AS-BUILT PLANS FOR INFORMATION ONLY

STATE OF ILLINOIS
DEPARTMENT OF PUBLIC WORKS & BUILDINGS
DIVISION OF HIGHWAYS

ROUTE NO.	SECTION	COUNTY	TOTAL SHEETS	SHEET NO.
11	38BR-1	VERMILION	116	28
13 SHEETS

F.A. PROJ F-13 (71)
GENERAL PLAN & ELEVATION
FA RT. 11 - SECTION 38BR
VERMILION COUNTY
STA. 8 + 97.50

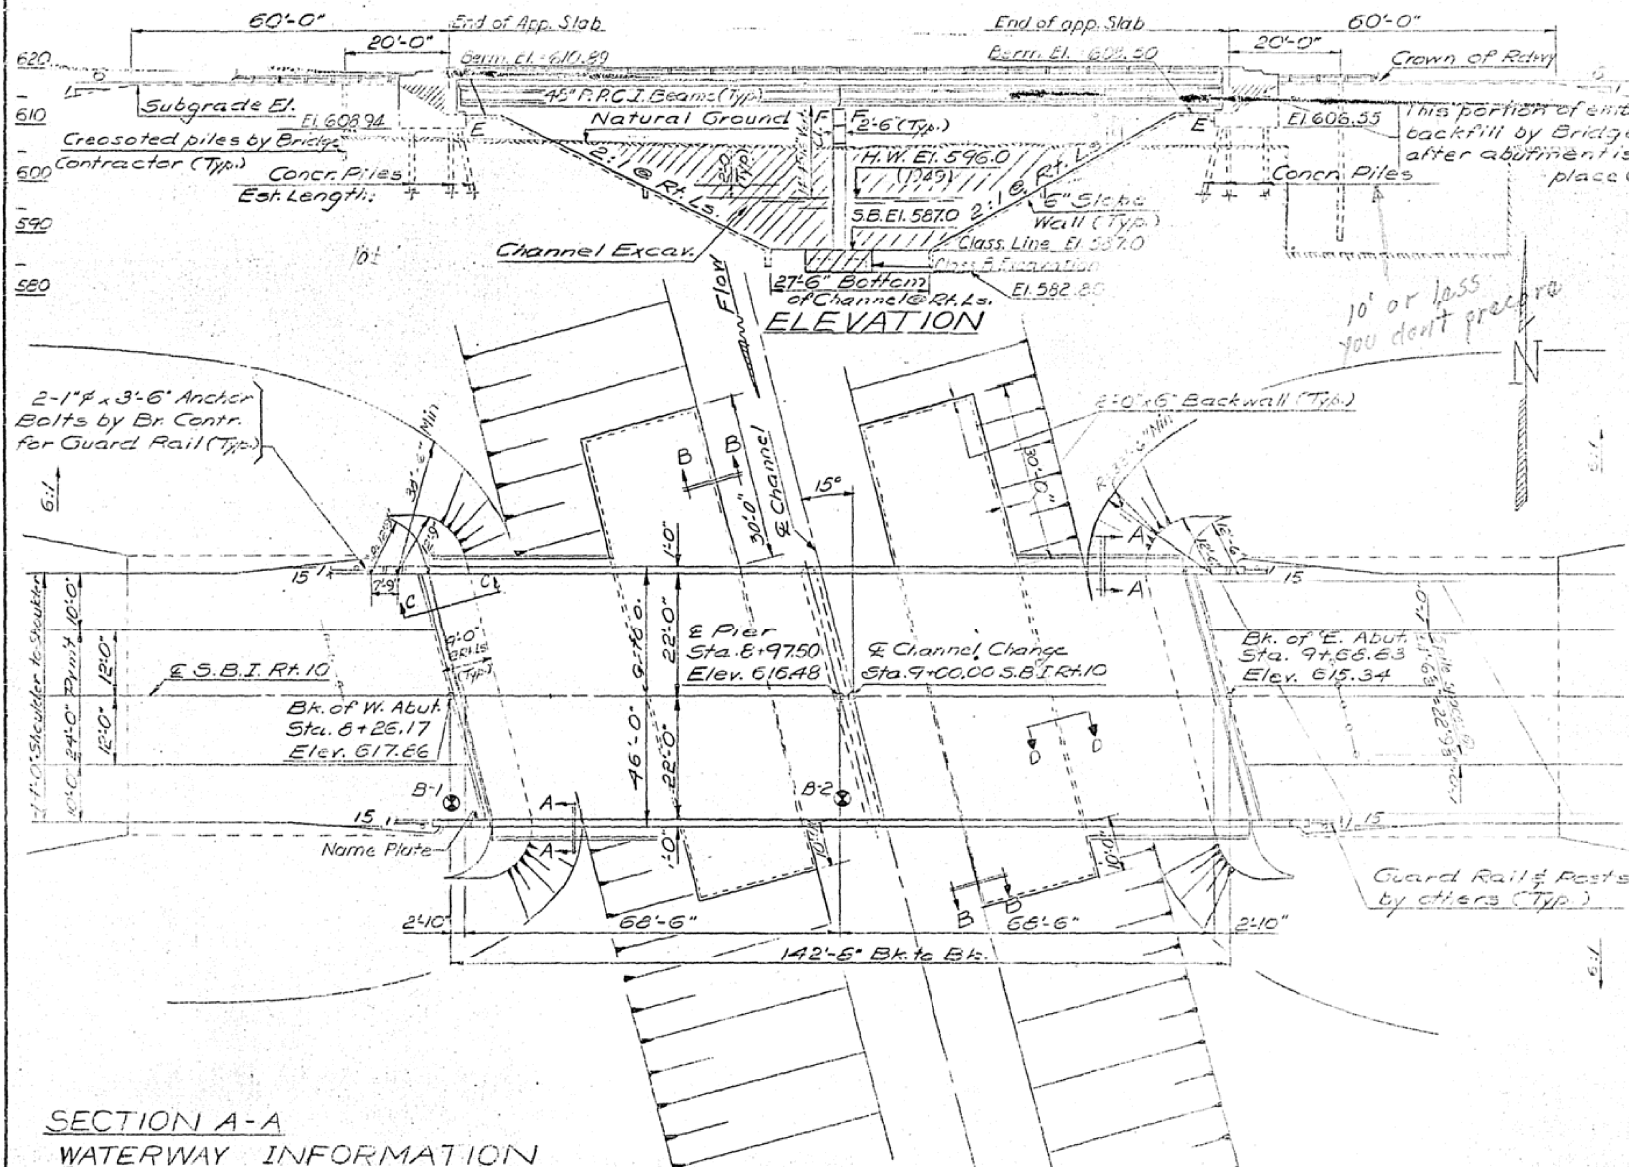
shouldn't be here
1-9-70
Z. Kowetz

1-9-70
Act. 573.04 (3) REFERS TO MEDIANA THROUGH ENR,
BUT Z. KOWETZ OF BR. OFF. SAID HE DON'T REBORE
THROUGH 10' OR LESS ENR, SO HE NEED NOT FOR THESE
ABUTTS.
Perhaps NOTIFIED Ren. ENR.
